**VALUE ENGINEERING STUDY**  
**OF**  
***KY 313 EXTENSION***  
**KY 1500 TO US 60**

**ITEM NUMBER: 4-297.21**  
**ITEM NUMBER: 4-297.23**  
**ITEM NUMBER: 4-297.27**

**Hardin & Meade Counties, Kentucky**

**February 11-15, 2008**

VE ALTERNATIVE 5 FT SHOULDER PAVEMENT

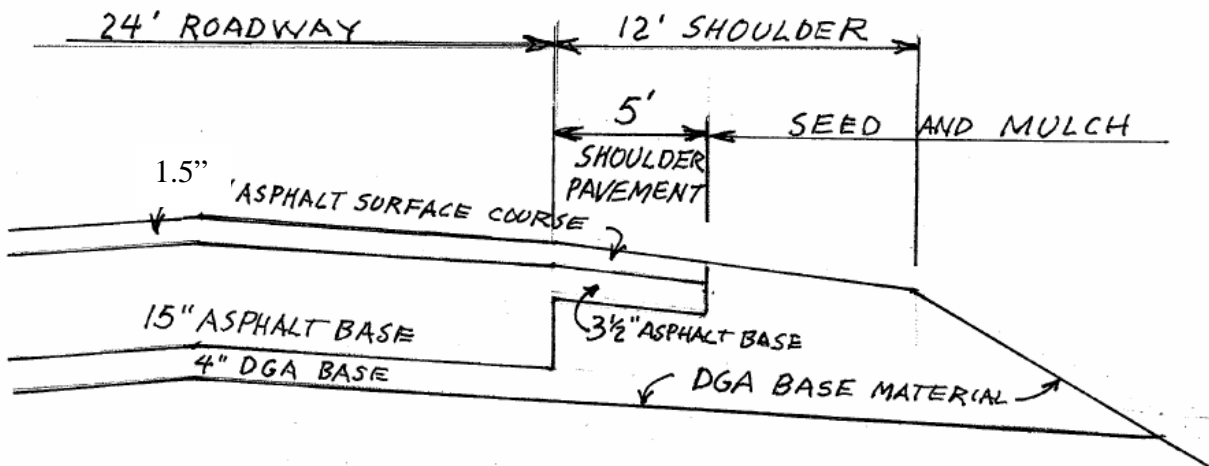
Value Engineering Alternative A recommends that only a 5' width of the shoulder be paved.

The remainder of the 12' shoulder area would be grassed upon the Dense Graded Aggregate shoulder surface.

The shoulder pavement design is the same as the "As Proposed".

The Value Engineering Team feels that the 5' paved shoulder is adequate for the cyclist and the occasional pedestrian, and to protect the edge of the travel lane pavement.

VALUE ENGINEERING ALTERNATIVE PAVEMENT DESIGN

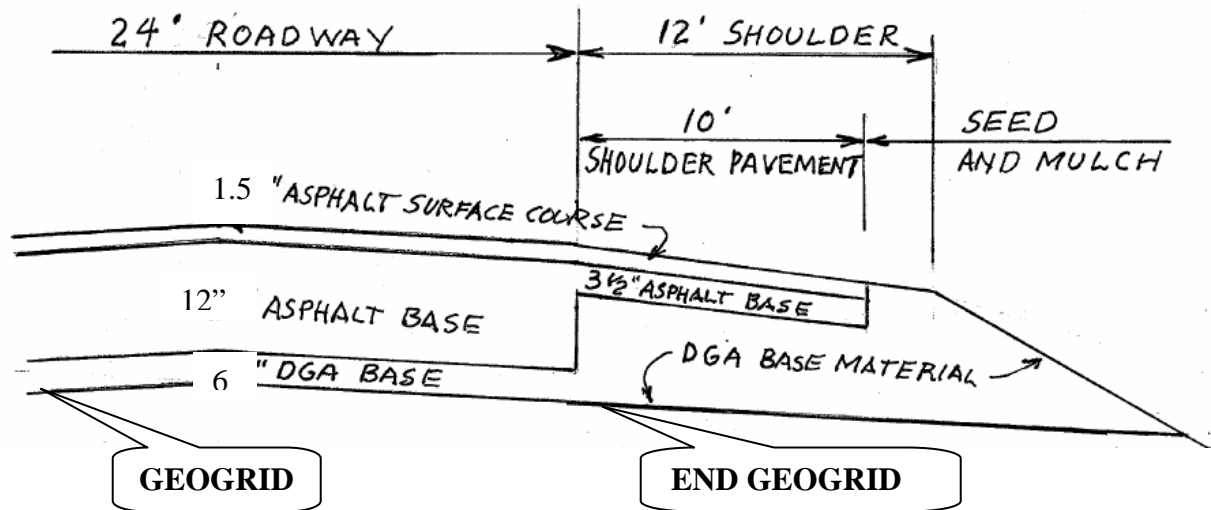
The Value Engineering Alternative Pavement Design consists of:

- Tensar BX 1200 Geogrid placed on the subgrade.
- 6"+/- of dense graded aggregate over the Geogrid.
- 12"+/- of CL3 ASPH BASE 0.75D PG64-22.
- The surface treatment is 1.5"+/- of CL3 ASPH SURF 0.38D PG64-22.

The Value Engineering Alternative increased the thickness of the proposed dense graded aggregate from 4 to 6" and decreased the proposed asphalt treated base from 15 to 12". The increase in thickness of the dense graded aggregate underlain by the geogrid provides a stiffer construction platform than the thinner DGA proposed. This will provide better protection for the subgrade from construction equipment operations.

AS PROPOSED BRIDGE OVER OTTER CREEK

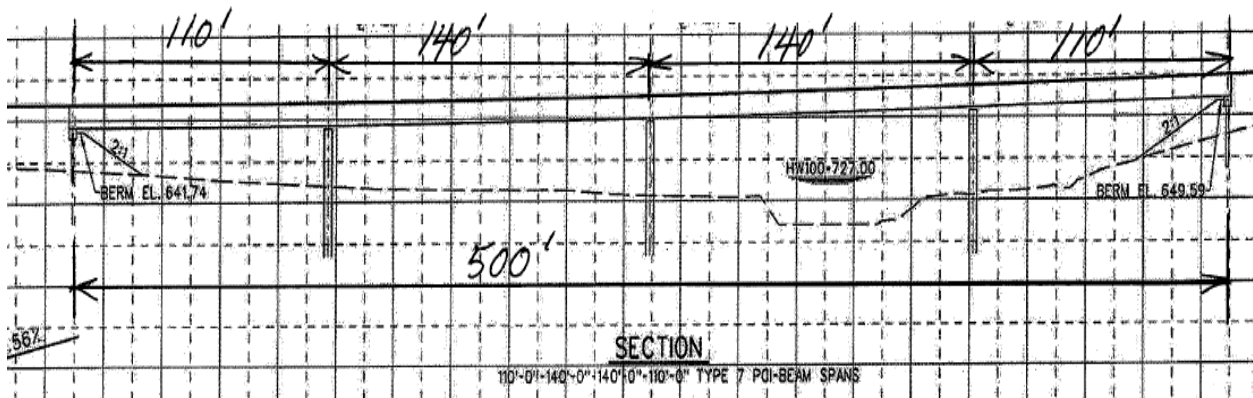
#### 1. "As Proposed"

The "As Proposed" bridge is a 500' long structure made up of 110', 140', 140', & 110' spans. The girders are Type 7 PCI-Beams continuous under live load supporting a 44' wide roadway. The End Bents are of the spill through type with 2 to 1 end slopes. The Interior Bents are post and beam type using 3 columns. The bridge is in a 700' sag vertical curve with the VPI near End Bent #1; the grades are -2.03% and +2.56%, and the horizontal alignment is a tangent section. At End Bent #1 the bottom of the girder clears the 100 yr. high water elevation by about 15'. Otter Creek is approximately 60' wide, bank to bank, and is 12' +/- deep from the bank top to the bottom of the channel. The center of the bridge is at Sta 161 + 61.50. Otter Creek passes under the bridge through the third span, which is 140' long, and there are no Interior Bents in the stream. It is mandated that the rise in backwater over the no bridge condition resulting from the 100 yr flood impacting the proposed bridge is zero. Therefore, the proposed bridge spans the entire flood area. It should be noted that the approach fills might be on soft ground associated with the Otter Creek flood plain.

#### VALUE ENGINEERING ALTERNATIVE NUMBER 1 BRIDGE OVER OTTER CREEK

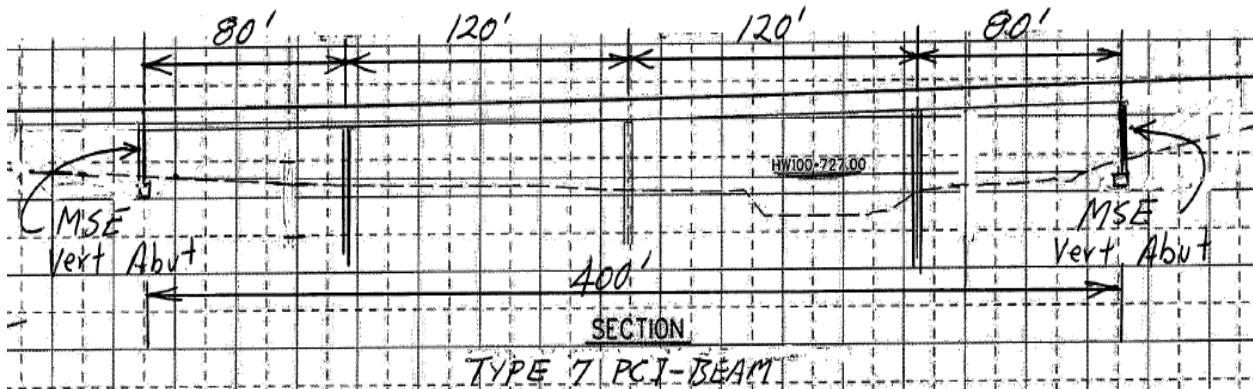
#### *Value Engineering Alternative Number 1*

This Value Engineering Alternate consists of a 400' structure made up of 80', 120', 120', and 80' spans. The girders are Type 7 PCI-Beams continuous under live load supporting a 44' wide roadway. The interior bents are post and beam type. The End Bents are pile supported in/on MSE vertical abutments. Settlement of the MSE abutment due to soft soils is likely in the flood plain and should be mitigated with a waiting period before driving end bent piles through cans or providing some means to reduce the down drag on the piles. The MSE wall face extends at 90 degrees to the Center Line from under the bridge out to the toe of the 2 to 1 side slope. There are no Interior Bents in the stream. Although the value engineering alternate is shorter than the proposed bridge, it is believed that the MSE abutments are founded above the 100 yr. high water elevation.

VALUE ENGINEERING ALTERNATIVE NUMBER 2 BRIDGE OVER OTTER CREEK

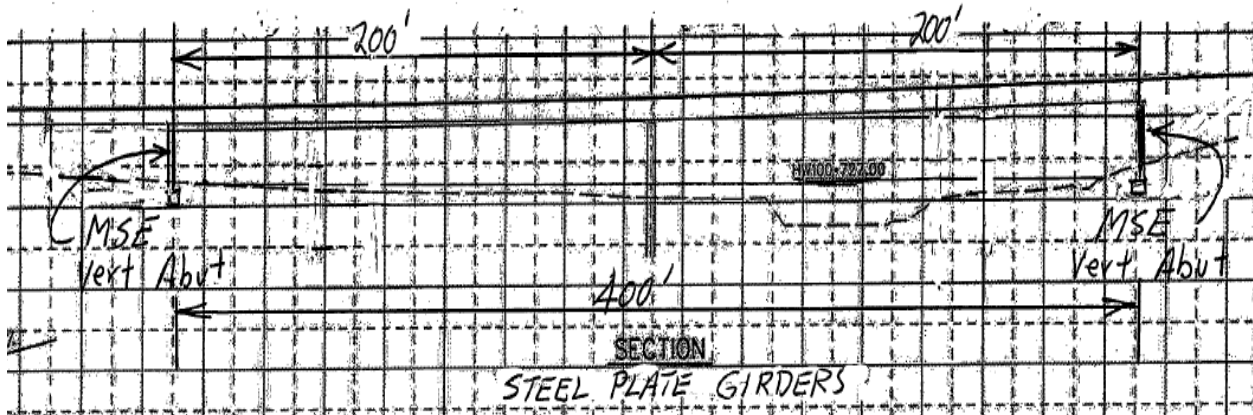
#### 3. Value Engineering Alternative Number 2

This Value Engineering Alternative consists of a 400' structure made up of two 200' spans. The beams are continuous steel plate girders supporting a 44' wide roadway. The interior bent is a post and beam. The End Bents are pile supported in/on MSE vertical abutments. Settlement of the MSE abutment due to soft soils is likely in the flood plain and should be mitigated with a waiting period before driving end bent piles through cans or providing some means to reduce the down drag on the piles. The MSE wall face extends at 90 degrees to the Center Line from under the bridge out to the toe of the 2 to 1 side slope. There are no Interior Bents in the stream. Although the value engineering alternate is shorter than the proposed bridge, it is believed that the MSE abutments are founded above the 100 yr. high water elevation.

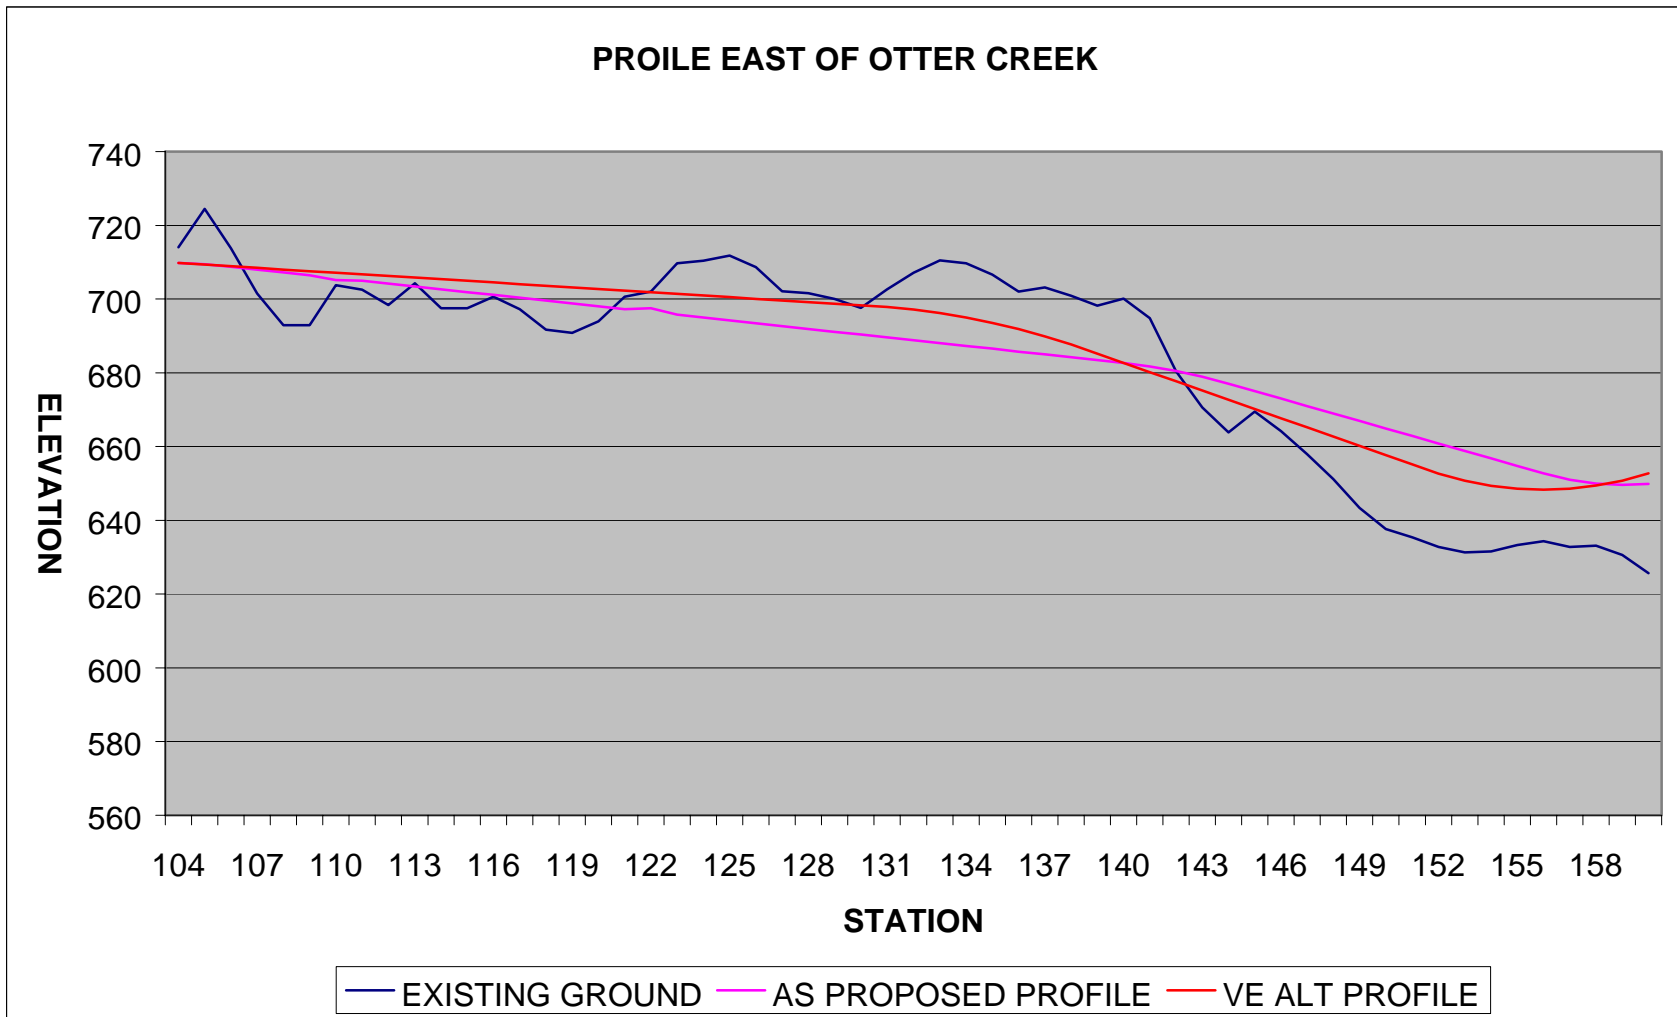
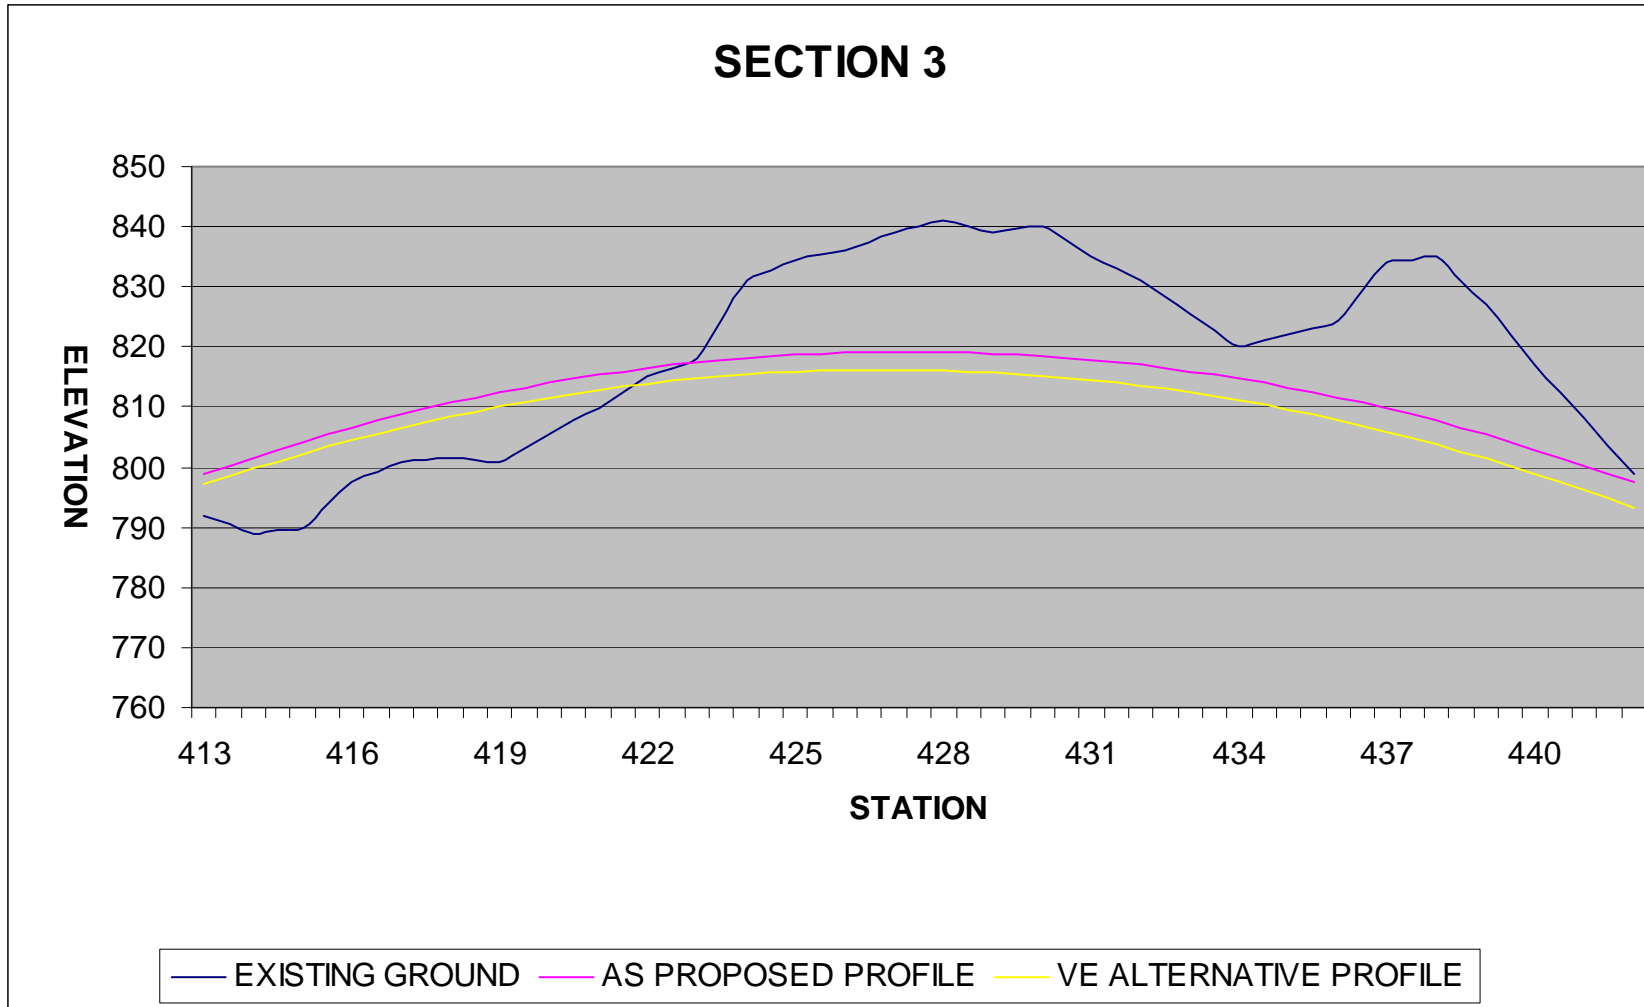
Based on the preliminary mass diagram, this construction section will require approximately 86,000 CY of offsite borrow to construct the embankments in this section. As shown on the profile drawings, a cut section extends from Sta 423 to Sta 442 with a cut in the 10' to 30' range. Additional excavation can be readily obtained in this area by lowering the elevation of the crest of the proposed 2,900' vertical curve approximately 3' with adjustments to the connecting grades at the PVC and the PVT. It is appropriate to note that these profile adjustments will slightly reduce the as proposed 3% grades to 2.9% and 2.88%.

Sketches showing the as proposed profile and the Value Engineering Alternative profile adjustment at the crest of the vertical curve are included on a following page.

As shown in the comparative cost tabulation sheet on a following page, the Value Engineering profile adjustments will provide a possible cost savings of approximately \$767,200 in earthwork costs. It is therefore recommended for inclusion in the final design .
